Subject: Class II permissive change Request

FCC ID: OKUTSB59030

1, Change model number MR4207,TSB-59030 to be CR4208, TSB-59031

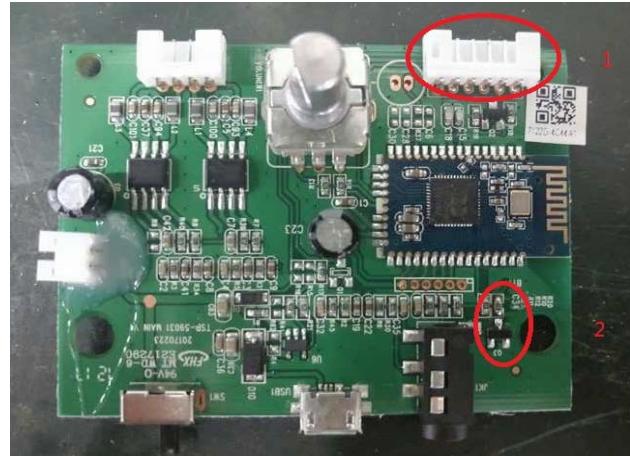
2, Add trade mark

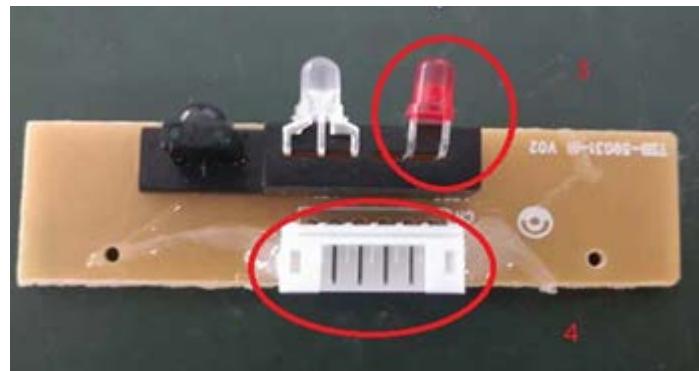
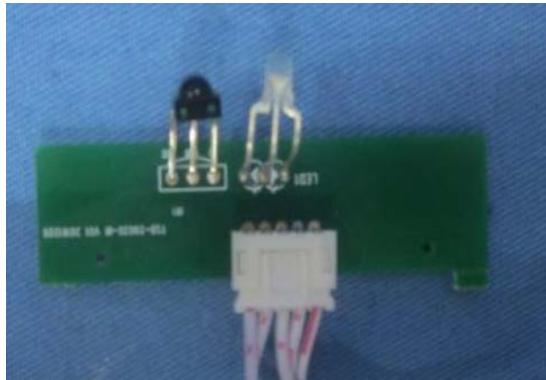
3, there have these differences between original and new: 5 pin change to 6 pin (marking 1 and marking 4), add a red light control switch triode (marking 2) and red LED (marking 3).

All difference do not influence RF performance and do not influence emission above 1GHz.
